Car Stereo
Service Bulletin

Model: CDX-R77, CDX-R79

No. 145

Subject: Volume Control Does Not Work

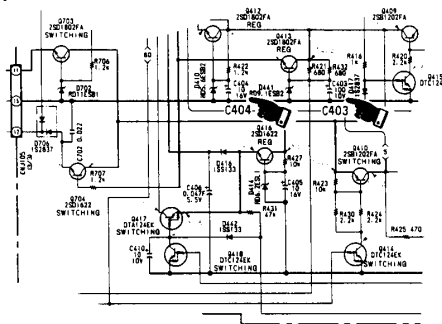
If the customer complains the volume control does not operate on hot days, please change the parts listed below:

At power up, the rise time for the analog and digital power supplies do not match causing the electrical volume to lock up.

Solution: Replace the following chemical capacitors:

Ref. No.	Former Part	New Part	
		Description	Part Number
C403	100 μ F/10V	47 μ F/16V	1-124-589-11
C404	10 μ F/16V	22 μ F/16V	1-124-234-00
